5.12.7. RIO NUEVO AREA (RNA) ZONING DESIGN STANDARDS

03 | PROPOSED SITE PLAN FARHANG AND MEDCOFF

05 | PROPOSED ELEVATIONS **FARHANG AND MEDCOFF**

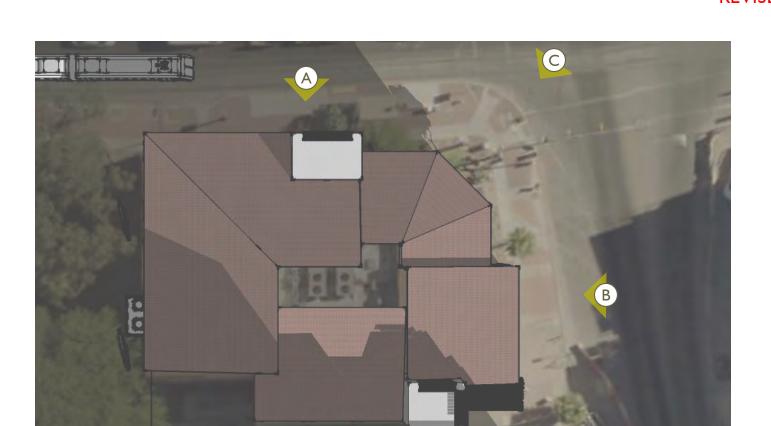
PROPOSED CHANGES

- NEW STUCCO FINISH FLUSH WITH ADJACENT WALL
- 2 SEALED STEEL TUBE FACADE
- 3 STUCCO FINISH WITH JOINTS IN A 24"X48" PATTERN AS SHOWN. ALIGN JOINTS WITH TOP OF COLUMN.
- 4 METAL PANEL ON FIRST FLOOR EAST FACADE
- 5 NOT USED.
- 6 PENETRATION ON FIRST FLOOR EAST FACADE WITH STOREFRONT WINDOW SYSTEM.
- 7 STEEL WALL FURR OUT TO SQUARE OFF CORNER AT NORTH STAIR CORE.
- 8 STEEL WINDOW BOX IN EXISTING OPENINGS ON THIRD FLOOR, REMOVE STUCCO POP OUT SURROUNDS.
- 9 LIGHTING AT STEEL CANOPY ENTRANCE

PROPOSED CHANGES

- NEW STUCCO FINISH FLUSH WITH ADJACENT WALL
- 2 PAINTED STEEL TUBE FACADE
- 3 24"X48" FIELD TILE.
- 4 METAL PANEL ON FIRST FLOOR EAST FACADE
- 5 PERFORATED METAL PANEL AT WINDOWS ON FIRST FLOOR EAST FACADE.
- 6 NOT USED.
- 5 STEEL WALL FURR OUT TO SQUARE OFF CORNER AT NORTH STAIR CORE.
- 8 STEEL WINDOW BOX IN EXISTING OPENINGS ON THIRD FLOOR, REMOVE STUCCO POP OUT SURROUNDS.
- 9 LIGHTING AT STEEL CANOPY ENTRANCE
